SUBSURFACE WASTEWATER DISPOSAL SYSTEM APPLICATION

Street or Road: 45 HAYDEN ROAD

Subject: Approval, Replacement System Variance Request, Angela Pease Property, 45 Hayden Road, Augusta, Maine. Mailing Address Owner/Applicant: Same.

SUBSURFACE WASTEWATER DISPOSAL SYSTEM VARIANCE REQUEST

SUBSURFACE WASTEWATER DISPOSAL PLAN

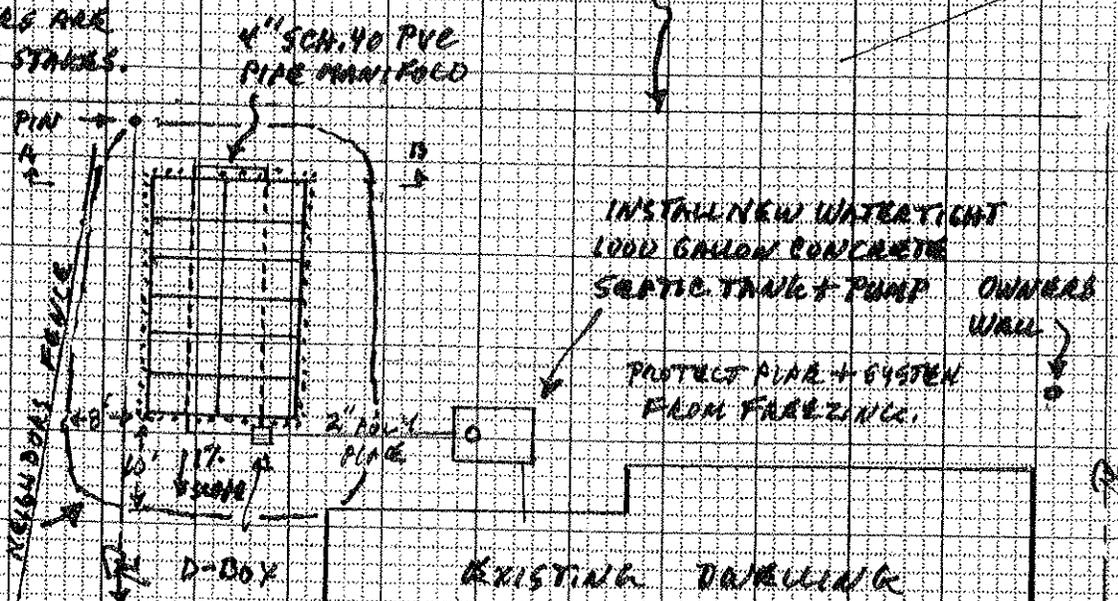
The variance request that is not within the LPI's authority is from the disposal field to the property line of 1 foot, no fill shall go over the property line without the proper easements, and to the full basement of 8 feet.

The variance request that is within the LPI's authority is the fill extensions of 3:1 slope, from the disposal field to a potable water supply of 76 feet, from the septic tank to a full basement of 5 feet, from the disposal field to a major water course of 88 feet and from the septic tank to a major water course of 80 feet.

The contractor is to scarify the soils under the fill extensions to create a transitional zone more compatible with the disposal field area.
